Product/Process Change Notice (PCN)

PCN #: PCN_SwDISV_20150104

Product Affected: WS-DISV

416 131 160 8XX (02,04,06,08,10,12 pole)

2) Material Changes:

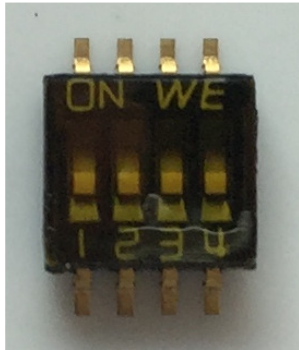
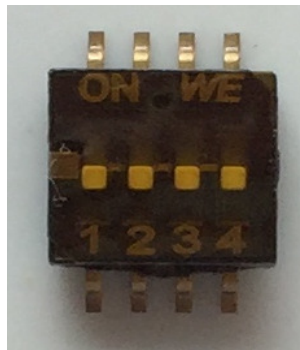
Old	New
Cover	PPS (Black)	PPA (Brown)
Base	PPS (Black)	PPA (Brown)
Actuator	PA46 (White)	PA46 (White)
Plating	Fully Gold	Fully Gold

3) Outer Appearance:
Previous Production

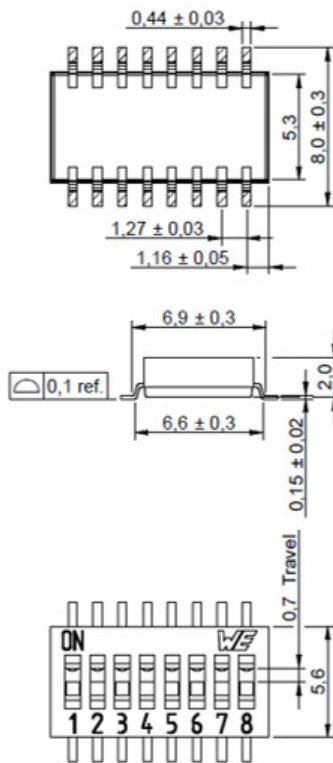
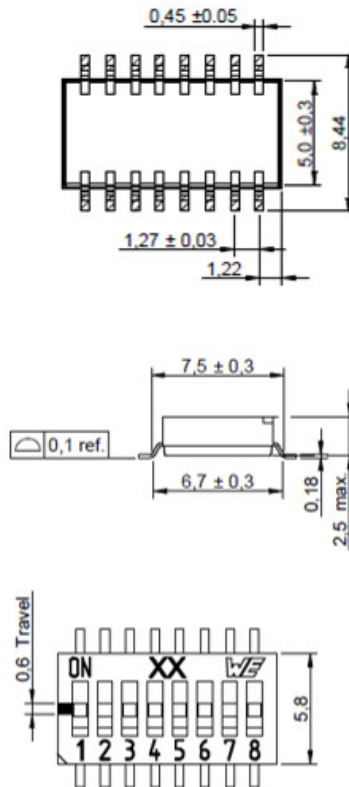
->Printing : change from INK to laser carving
->Pole from 06 on, additional date code on cover as additional identification
>XX explanation as below
